#### CITY OF CORPUS CHRISTI ENGINEERING SERVICES CHANGE ORDER

CHANGE ORDER NO: 8 - COUNCIL CHANGE ORDER DATE: 6/15/2020 PROJECT: PROJECT NUMBER: E15112 Rodd Field Rd. - Yorktown Blvd. to Saratoga Blvd. (Bond 2014) CONTRACTOR: Haas-Anderson Construction, Ltd. ORIGINAL CONTRACT TIME: 810 CD's **ENGINEER:** LJA Engineering Make the following additions, modifications or deletions to the work described in the Contract Documents: ADDITIONS Quantity Unit **Unit Price** Total **Master Channel 31 Changes** E - New 8 Master Channel 31 Changes - Culvert Rehab & Replacement FPP \$ 1,436,822.00 \$ 1,436,822.00 Η1 Gas Line Trench Excavation, Bedding, & Backfill 200 LF \$ 19.00 \$ 3,800.00 1.10 \$ 220.00 H2 Pipe Trench Safety 200 LF \$ Additions Total: \$ 1,440,842.00 DELETIONS Reconciliation E53 Concrete Headwall -1 EA \$ 18,800.00 \$ (18,800.00)E54 -2 10,300.00 \$ (20,600.00)Concrete Wingwall -0.25 3,020.00 \$ (755.00)E56 42" RCP Outfall Penetration Repair EA -0.25 3,020.00 \$ (755.00)E58 54" RCP Outfall Penetration Repair EA **Deletions Total: \$** (40,910.00)Additional Calendar Days requested 122 NET TOTAL OF THIS CHANGE ORDER: \$ 1,399,932.00

Re: Proposal for Master Channel 31 Changes Rev1

# **Exhibit 1: Opinion of Probable Construction Costs of All Three Options**

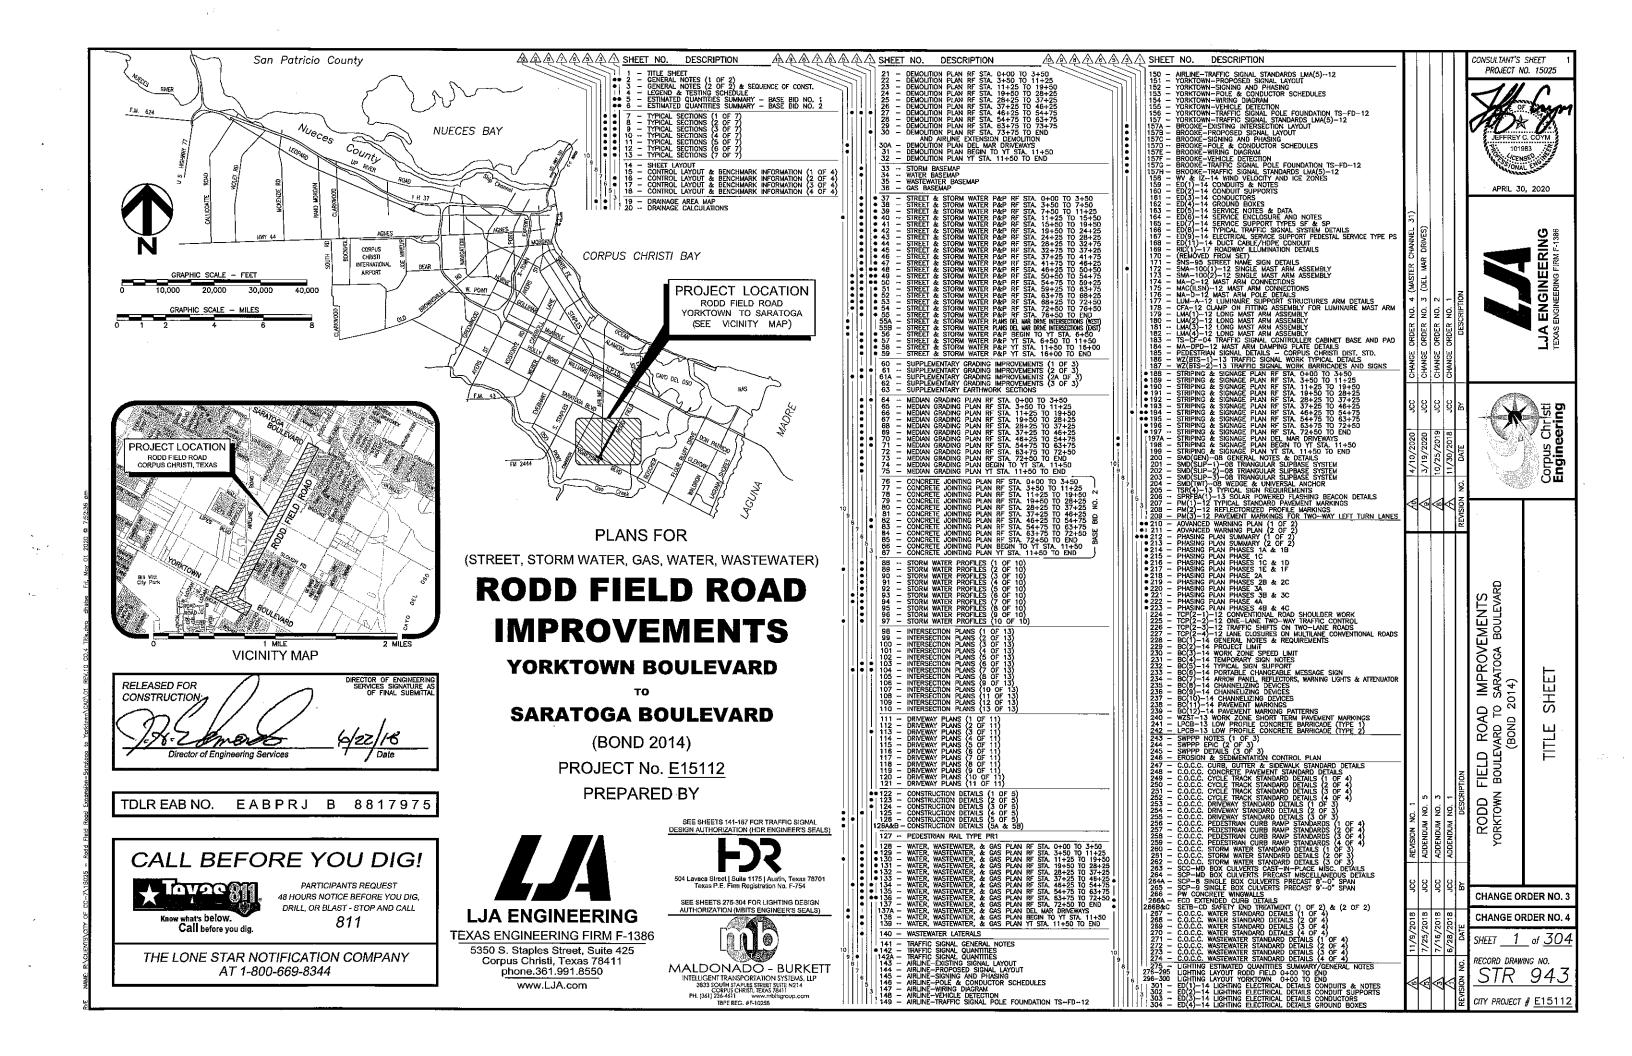
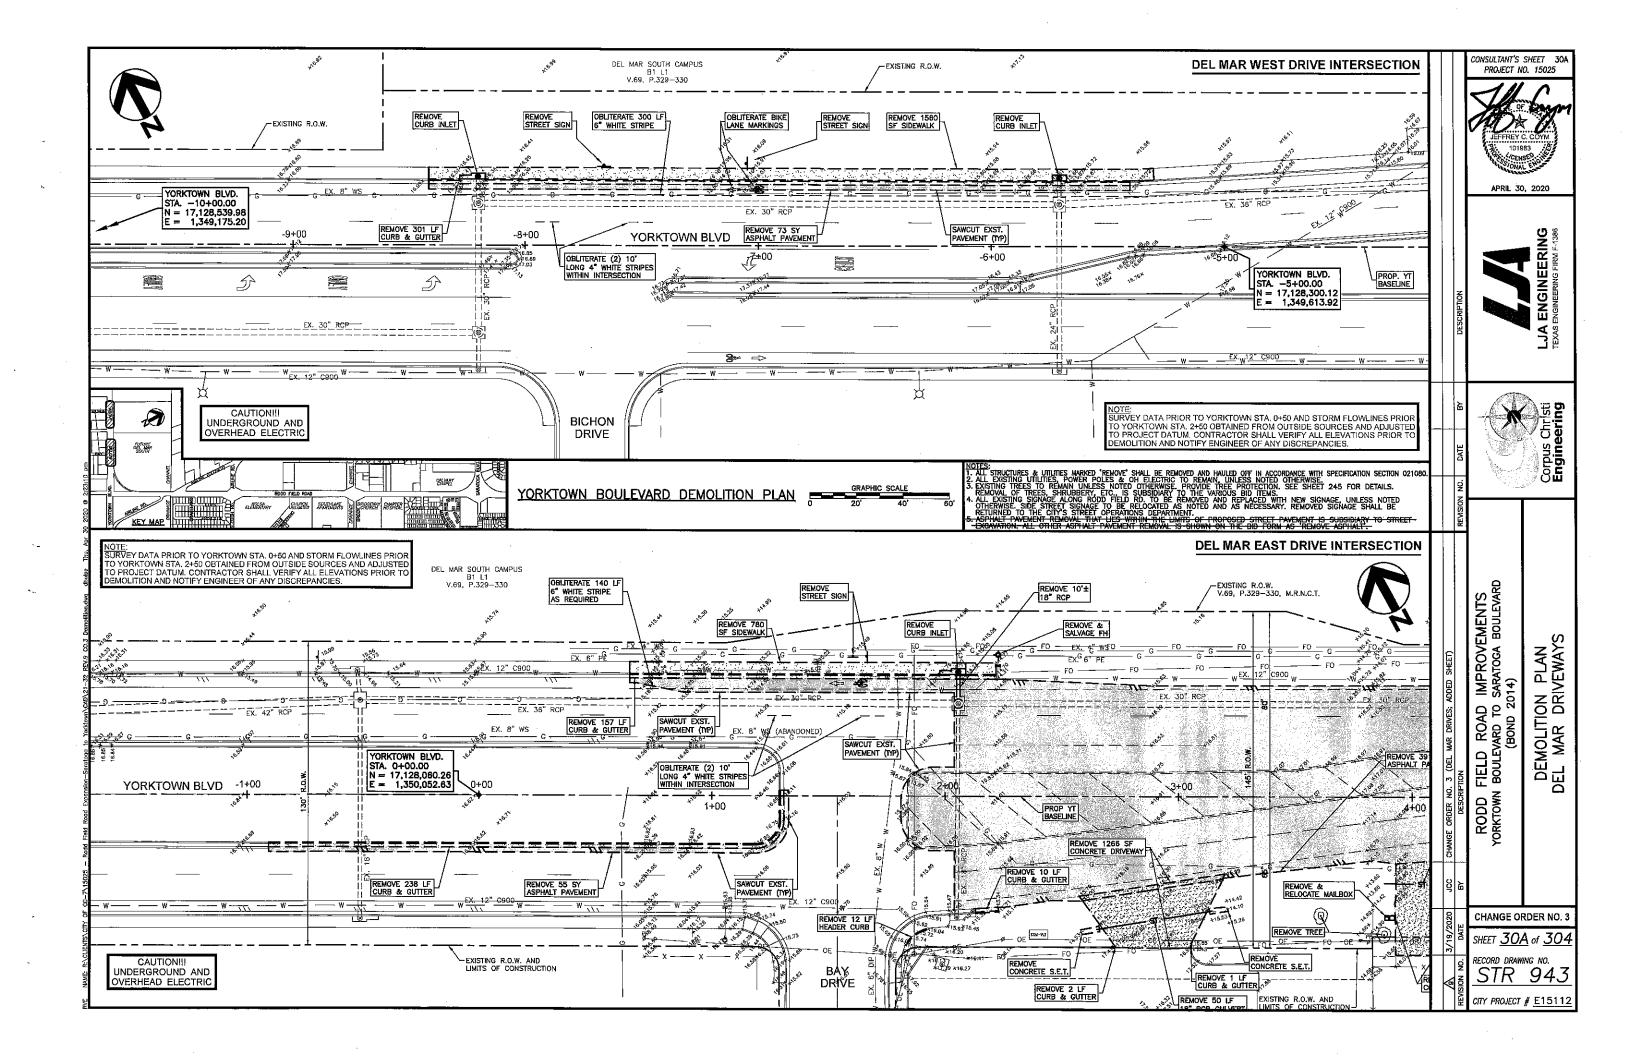
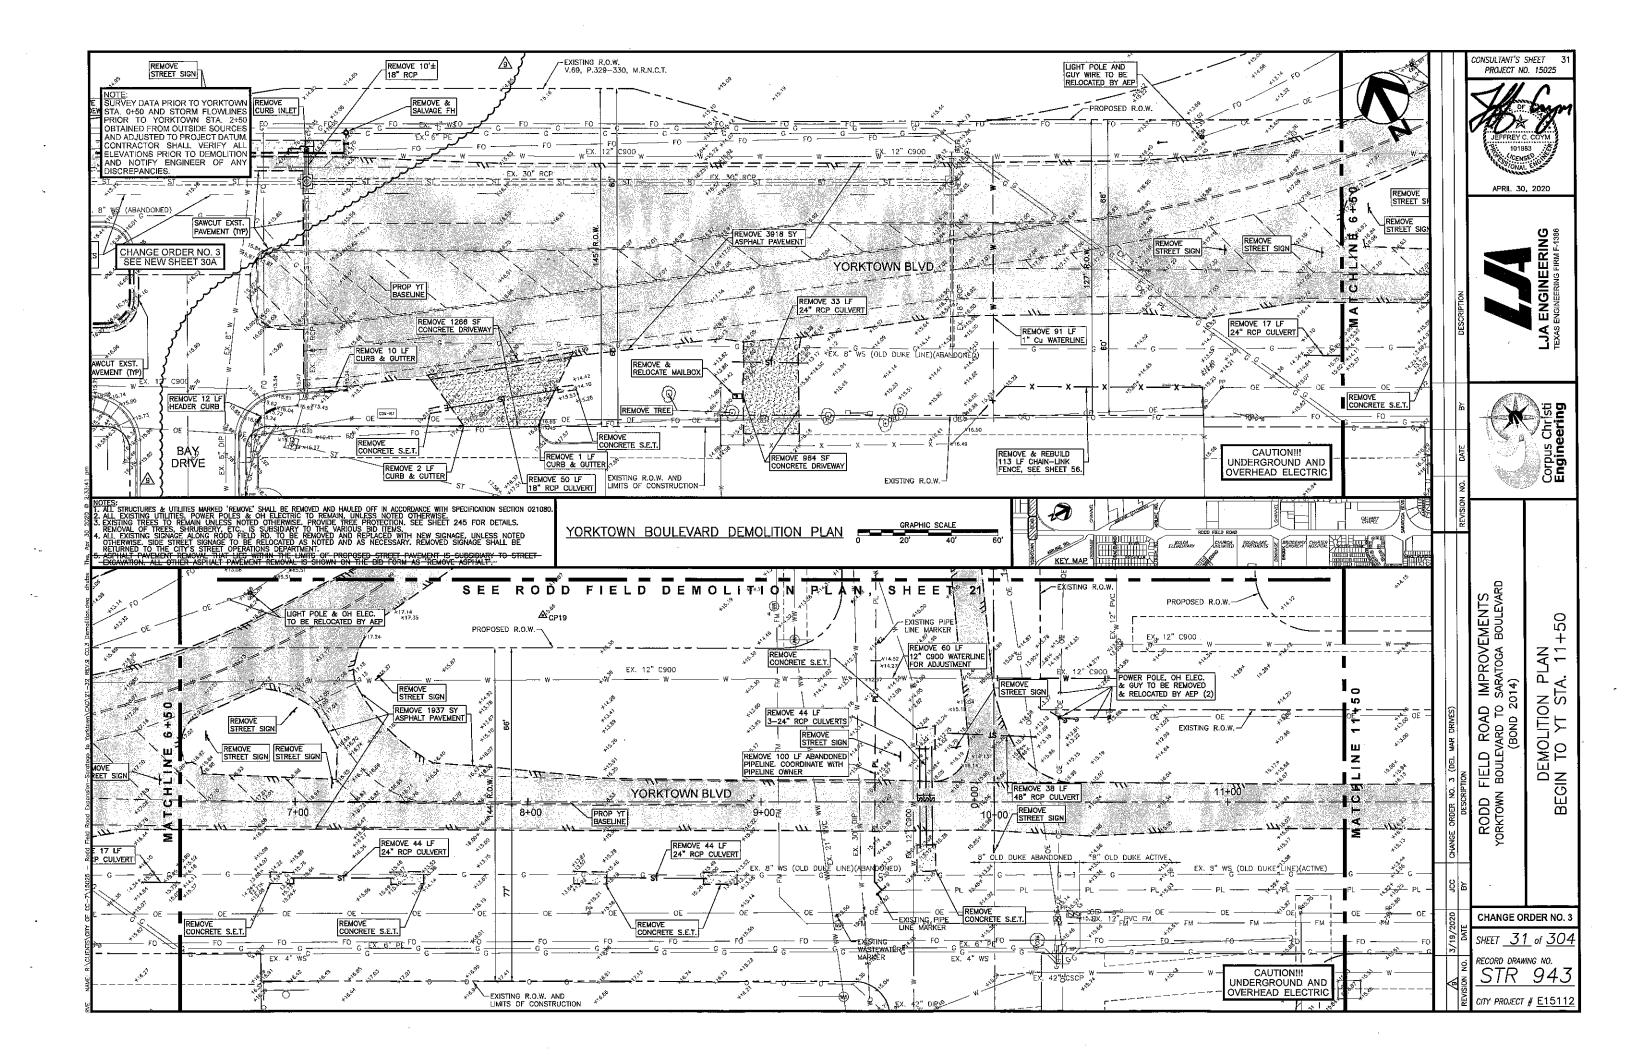
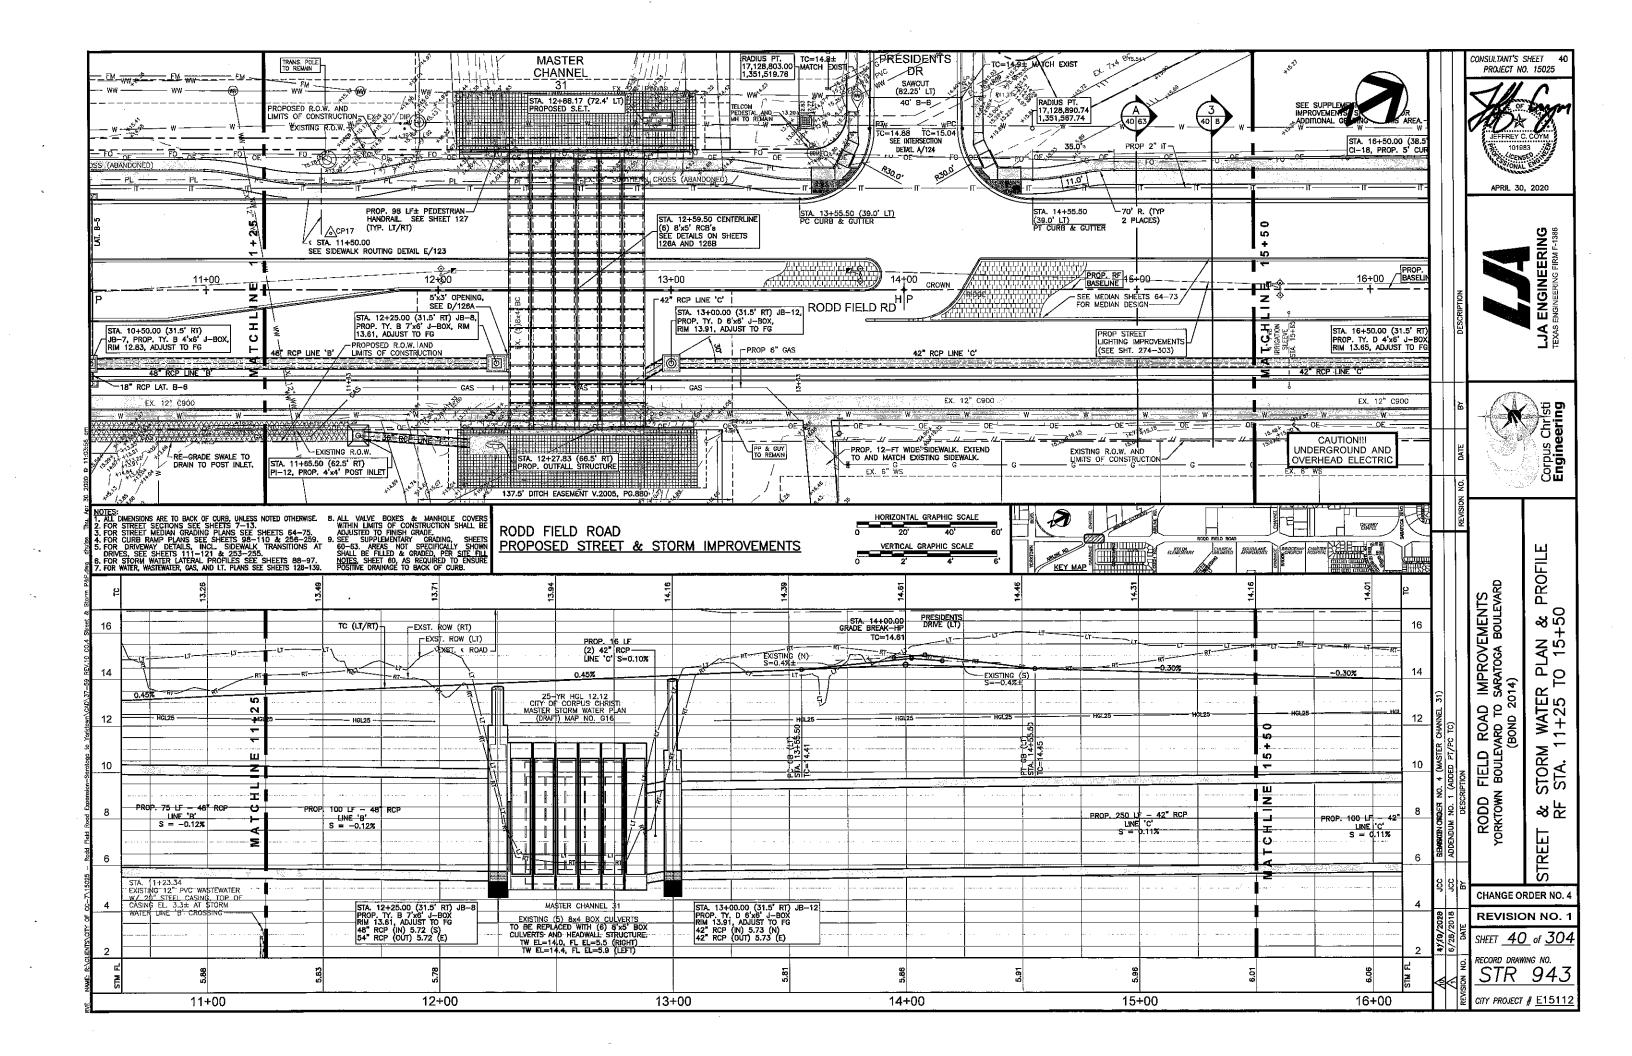
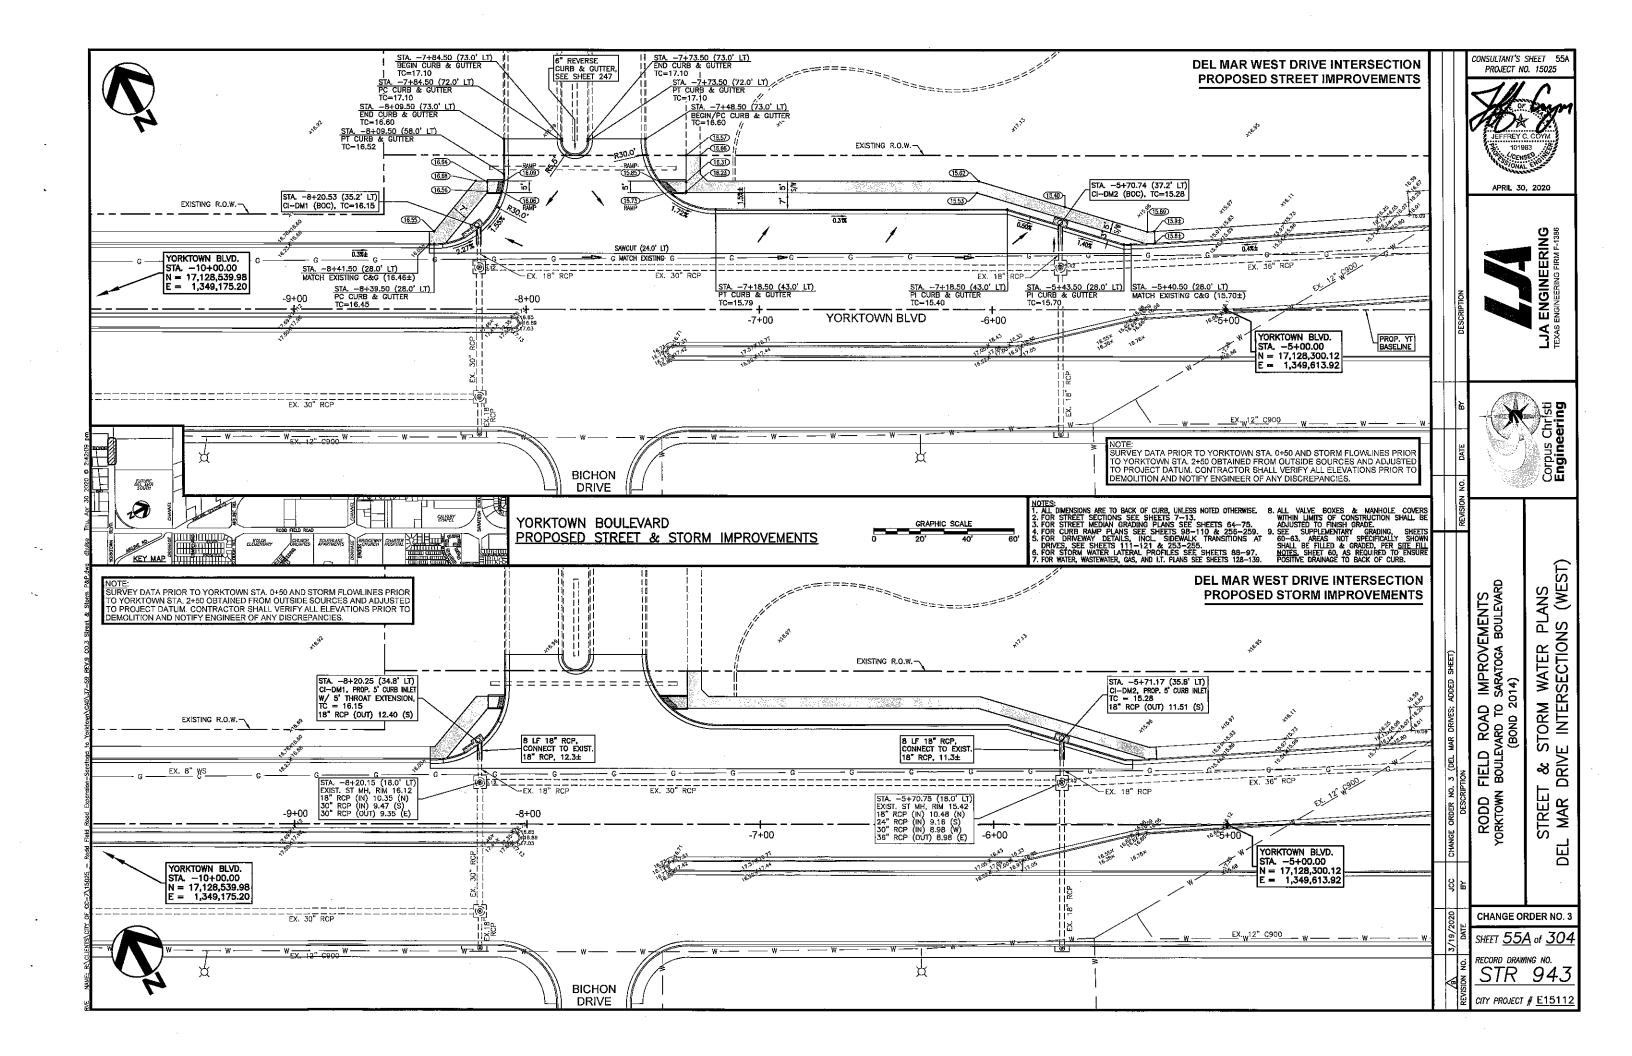
OPTION 1	- REPAIR EXISTING CULVERTS				
ITEM	DESCRIPTION	UNIT	QTY	UNIT PRICE	AMOUNT
429-6009	Concrete Structure Repair (Standard)	SF	1,200	\$185.00	\$222,000.00
	Dewatering & Sheet Piling	LF	180	\$500.00	\$90,000.00
				Subtotal	\$312,000.00
			Conf	tingencies (10%)	\$31,200.00
			TO	TAL OPTION 1	\$343,200.00

OPTION 2	- REPLACE EXISTING STRUCTURE IN KIND				
ITEM	DESCRIPTION	UNIT	QTY	UNIT PRICE	AMOUNT
496-6001	Remove Structure (Box Culvert)	EA	1	\$30,000.00	\$30,000.00
496-6006	Remove Structure (Headwall)	EA	2	\$15,000.00	\$30,000.00
462-6019	Concrete Box Culvert (8 ft x 4 ft)	LF	600	\$580.00	\$348,000.00
466-6234	Headwall	EA	2	\$20,000.00	\$40,000.00
	Dewatering & Sheet Piling	LF	180	\$500.00	\$90,000.00
				Subtotal	\$538,000.00
			Cont	ingencies (10%)	\$53,800.00
			ТО	TAL OPTION 2	\$591,800.00

OPTION 3	- REPLACE AND UPSIZE EXISTING STRUCTURE				
ITEM	DESCRIPTION	UNIT	QTY	UNIT PRICE	AMOUNT
496-6001	Remove Structure (Box Culvert)	EA	1	\$30,000.00	\$30,000.00
496-6006	Remove Structure (Headwall)	EA	2	\$15,000.00	\$30,000.00
462-6020	Concrete Box Culvert (8 ft x 5 ft)	LF	720	\$620.00	\$446,400.00
466-6234	Headwall	EA	2	\$20,000.00	\$40,000.00
	Dewatering & Sheet Piling	LF	180	\$500.00	\$90,000.00
				Subtotal	\$636,400.00
			Cont	ingencies (10%)	\$63,640.00
			TO	TAL OPTION 3	\$700,040.00

LIA Engineering recommends the City selects **Option 3: Replace and Upsize Existing Structure**. Given the abundance of vacant land in the adjacent area and the catalyst of the Del Mar College development that will most likely spark additional developments in the area, it only makes sense to increase the capacity of the culvert structure. We realize that the budget is a constraint but feel that this Option, in the long run is in the best interest of the City.
